Revision										A	04/03/25	Roof Lanterns removed and side window added					S BIDDLE Ltd Email: stephen@sbiddle.co.uk	Stephen Biddle BSc CEng FICE Mob: 07864 122 313 Web: www.sbiddle.co.uk		
				Revision																			
					A	04/03/25	Roof Lanterns removed and side window added																
Client	Mr & Mrs A. Cox																						
Address	68 Western Avenue, Woodley, Reading RG5 3BH																						
Drwg No	COX-1124-02		Scale: (A2)	1:100																			
Title	PROPOSED ELEVATIONS																						
					2m	4m	6m	8m

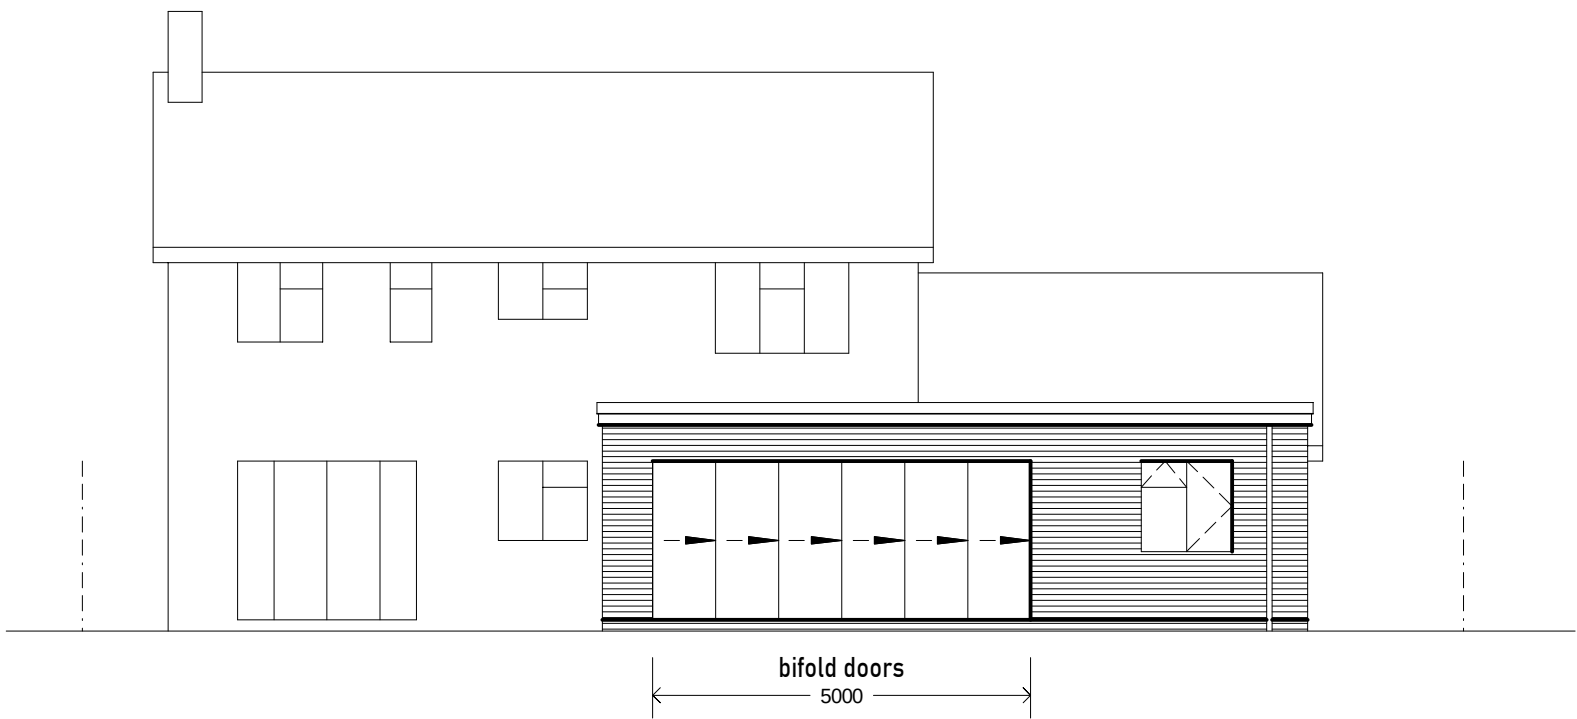
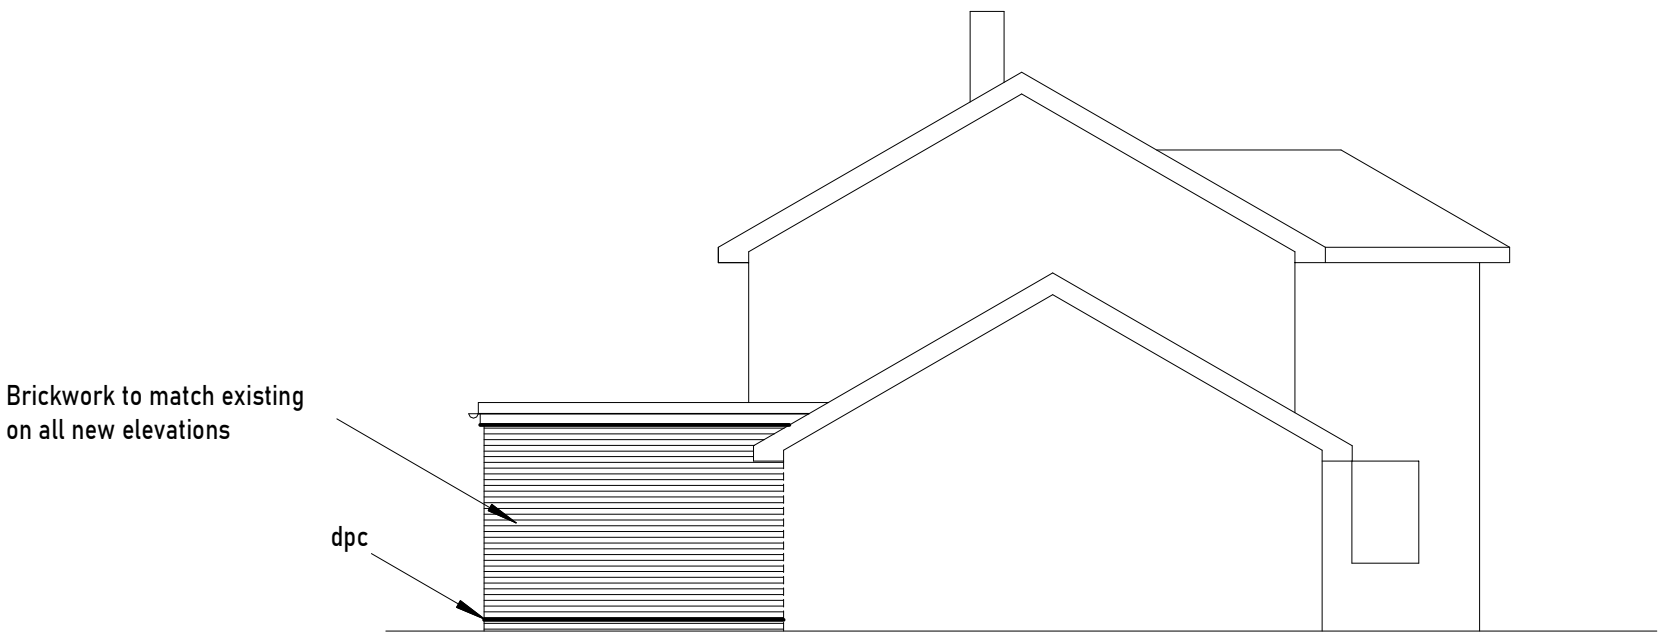
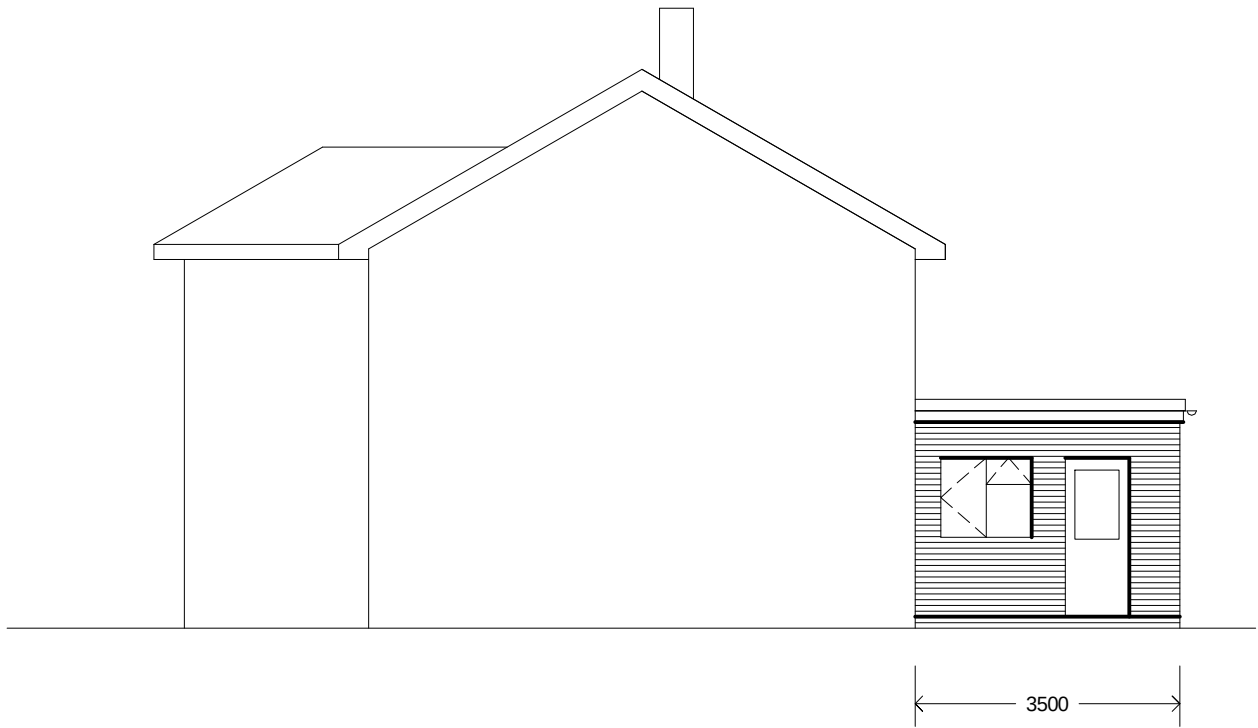
<table><tr><td rowspan="5">Revision</td><td></td><td></td><td></td></tr><tr><td>A</td><td>04/03/25</td><td>Roof Lanterns removed and side window added</td></tr></table>
